Groundwater Transfer Review Summary Form

Transfer/PA # T- 14931

Application: T-14931

Applicant Name: David Leavy

Well Interference Analysis: MARI 299/Well 2-TL 200

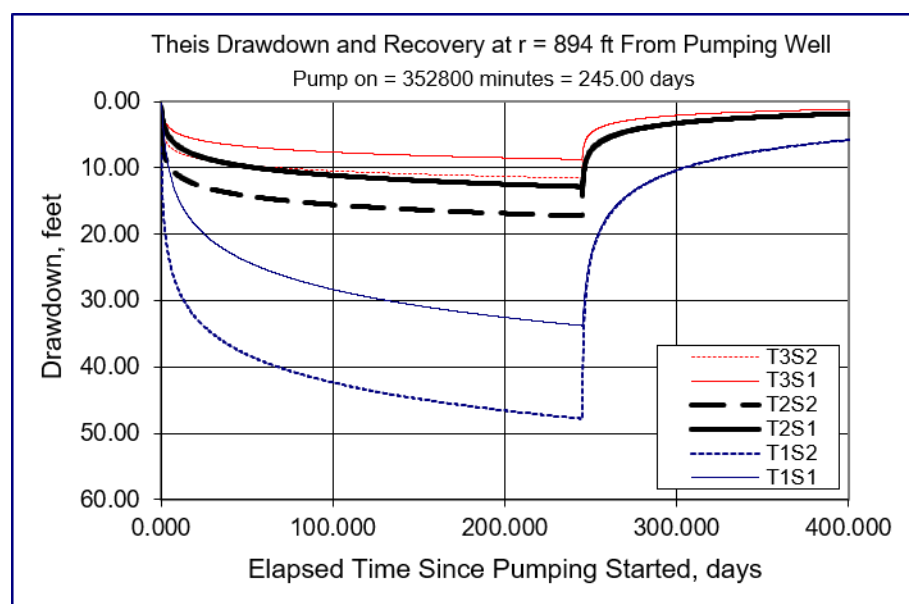
Input Data:	Var Name	Scenario 1	Scenario 2	Scenario 3	Units	
Total pumping time	t		245		d	
Radial distance from pumped well:	r		1585		ft	Q conversions
Pumping rate	Q		0.976384		cfs	438.20 gpm
Hydraulic conductivity	K	11	35	55	ft/day	0.98 cfs
Aquifer thickness	b		100		ft	58.58 cfm
Storativity	S 1		0.003			84,359.58 cfd
	S 2		0.0003			1.94 af/d
Transmissivity Conversions	T_f2pd	1100	3500	5500	ft ² /day	Recalculate
	T_f2pm	0.76388889	2.43055556	3.81944444	ft ² /min	
	T_gpdft	8228	26180	41140	gpd/ft

The non-subject application water right rates could not be used for the entire 245-day irrigation season without exceeding the respective maximum annual volumes. The time-averaged rate of 0.810784 (364 gpm) in combination with the subject application rate of 0.1656 cfs (74.3 gpm) is used for a combined rate of 0.976 cfs (438 gpm).

SWL	30	ft bls	Woodward et al., 1998
Aquifer Bottom	195	ft bls	Woodward et al., 1998
Available Water Column	165	ft	Aquifer bottom-SWL
Pump Height Above Bottom	5	ft	Estimate
NPSHa	5	ft	Estimate
Drawdown	10	ft	Estimate
Minimum Water Column	20	ft	Estimated Drawdown + NPSHa + Pump Height
Injury	145	ft	Available Water Column-Minimum Water Column

Well Interference Analysis: MARI 18753/Well 3-MARI 50620

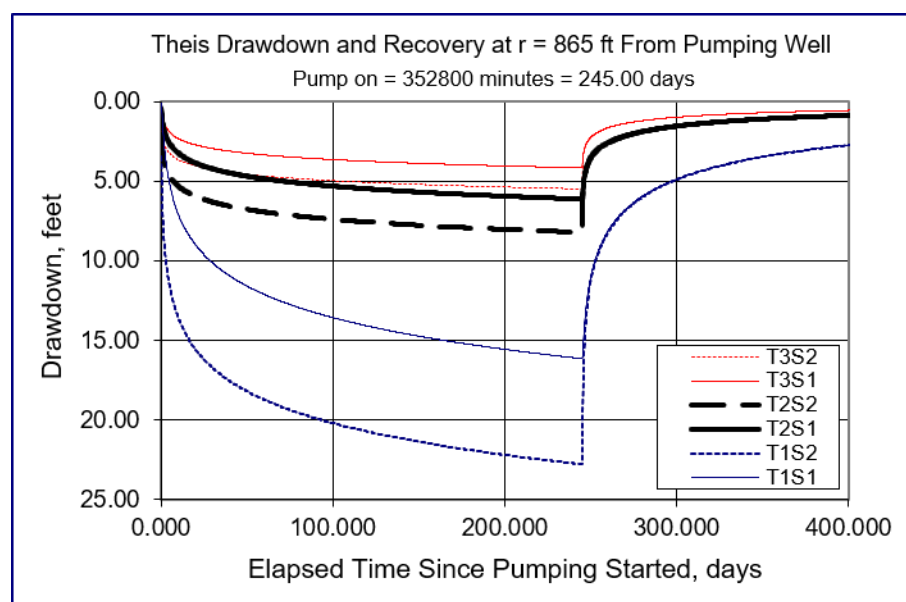
Input Data:	Var Name	Scenario 1	Scenario 2	Scenario 3	Units	
Total pumping time	t		245		d	
Radial distance from pumped well:	r		894		ft	Q conversions
Pumping rate	Q		0.976384		cfs	438.20 gpm
Hydraulic conductivity	K	11	35	55	ft/day	0.98 cfs
Aquifer thickness	b		100		ft	58.58 cfm
Storativity	S 1		0.003			84,359.58 cfd
	S 2		0.0003			1.94 af/d
Transmissivity Conversions	T_ftpd	1100	3500	5500	ft ² /day	Recalculate
	T_ft2pm	0.76388889	2.43055556	3.81944444	ft ² /min	
	T_gpdft	8228	26180	41140	gpd/ft

The non-subject application water right rates could not be used for the entire 245-day irrigation season without exceeding the respective maximum annual volumes. The time-averaged rate of 0.810784 (364 gpm) in combination with the subject application rate of 0.1656 cfs (74.3 gpm) is used for a combined rate of 0.976 cfs (438 gpm).

SWL	47.67	ft bls	most recent SWL for MARI 50620
Aquifer Bottom	195	ft bls	Woodward et al., 1998
Available Water Column	147.33	ft	Aquifer bottom-SWL
Pump Height Above Bottom	5	ft	Estimate
NPSHa	5	ft	Estimate
Drawdown	91	ft	MARI 50620/Certificate 80433
Minimum Water Column	101	ft	Estimated Drawdown + NPSHa + Pump Height
Injury	46	ft	Available Water Column-Minimum Water Column

Well Interference Analysis: MARI 303/to-POA- MARI 50620

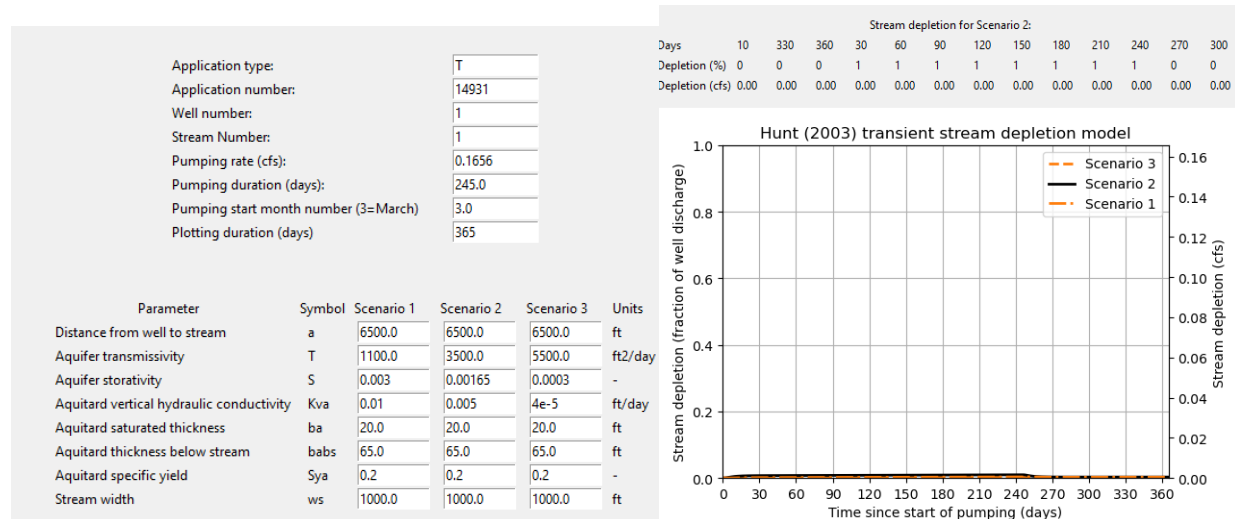
Input Data:	Var Name	Scenario 1	Scenario 2	Scenario 3	Units	
Total pumping time	t		245		d	
Radial distance from pumped well:	r		865		ft	Q conversions
Pumping rate	Q		0.461339		cfs	207.05 gpm
Hydraulic conductivity	K	11	35	55	ft/day	0.46 cfs
Aquifer thickness	b		100		ft	27.68 cfm
Storativity	S 1		0.003			39,859.69 cfd
	S 2		0.0003			0.92 af/d
Transmissivity Conversions	T_ftpd	1100	3500	5500	ft ² /day	Recalculate
	T_ft2pm	0.76388889	2.43055556	3.81944444	ft ² /min	
	T_gpdft	8228	26180	41140	gpd/ft

The non-subject application water right rates could not be used for the entire 245-day irrigation season without exceeding the respective maximum annual volumes. The time-averaged rate of 0.33 cfs (149 gpm) in combination with the subject application rate of 0.129 cfs (57.9 gpm) is used for a combined rate of 0.461 cfs (207 gpm).

SWL	47.67	ft bls	most recent SWL for MARI 50620
Aquifer Bottom	195	ft bls	Woodward et al., 1998
Available Water Column	147.33	ft	Aquifer bottom-SWL
Pump Height Above Bottom	5	ft	Estimate
NPSHa	5	ft	Estimate
Drawdown	91	ft	MARI 50620/Certificate 80433
Minimum Water Column	101	ft	Estimated Drawdown + NPSHa + Pump Height
Injury	46	ft	Available Water Column-Minimum Water Column
